# Access Compliance Report

## Public Rights-of-Way

### (Curb Ramps)

Intersection ID: 51635	Main Street: NATIONS_FORD_RD	Cross Street: TOCCOA_FALLS_DR	Location: SW
ADA ID: 6DC0856F8C4C	Ramp Type: BlendTrans1	Initial Pass/Fail: Fail	Overall Compliance: No
Severity Score: 10			
Codes/Mitigation Info/Possible Solution		Field Measurements/Component Compliance

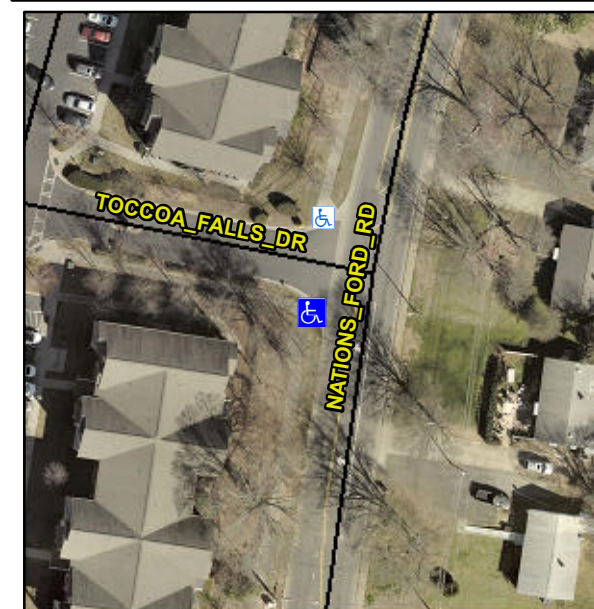
Compliance	Description	Data	Compliance	Description	Data
N/A	Ramp Length (in)	105.0	Yes	BlendTrans Slope (%)	3.8
No	Ramp Width (in)	46.5	No	BlendTrans XSlope (%)	4.7
N/A	Flare Type LT	N/A	N/A	Flare Type RT	N/A
N/A	Flare Slope LT (%)	N/A	N/A	Flare Slope RT (%)	N/A
N/A	Flare Traversable LT?	N/A	N/A	Flare Traversable RT?	N/A
N/A	Landing Length (in)	N/A	N/A	DWS Provided?	N/A
N/A	Landing Width (in)	N/A	N/A	DWS Contrast?	N/A
N/A	Landing Slope (%)	N/A	N/A	DWS Length (in)	N/A
N/A	Landing X Slope (%)	N/A	N/A	DWS Full Width?	N/A
N/A	Landing Curb? (Y/N)	N/A	N/A	DWS Offset (in)	N/A
N/A	Shared Landing?	N/A			
N/A	Gutter Ponding?	N/A	N/A	Gutter Slope (%)	N/A
N/A	Gutter Lip Ht (in)	N/A	N/A	Gutter X Slope (%)	N/A
N/A	Painted X Walk1?	No	N/A	Painted X Walk2?	No
	X Walk 1 Direction	To E		X Walk 2 Direction	To N
	X Walk 1 Width (in)	N/A		X Walk 2 Width (in)	N/A
	X Walk 1 Slope (%)	6.9		X Walk 2 Slope (%)	3.8
	X Walk 1 X Slope (%)	3.5		X Walk 2 X Slope (%)	3.9

N/A	Ramp inside XWalk1?	N/A	N/A	Ramp inside XWalk2?	N/A
	Road Slope (%)	4.5		Clear Space?	N/A
	Road X Slope (%)	2.1	N/A	Clear Space to XWalk (in)	N/A
N/A	Any Obstructions?	N/A	N/A	Storm Grate/Utility Hazard?	N/A
	Obstruction Type			Storm Grate/Utility Type	
		N/A			N/A
			Yes	Surface Condition? (G/P)	Good
			N/A	Curb Slope (%)	2.7

**Remove & Replace Curb Ramp With Two New Directional Ramps or Equivalent.**
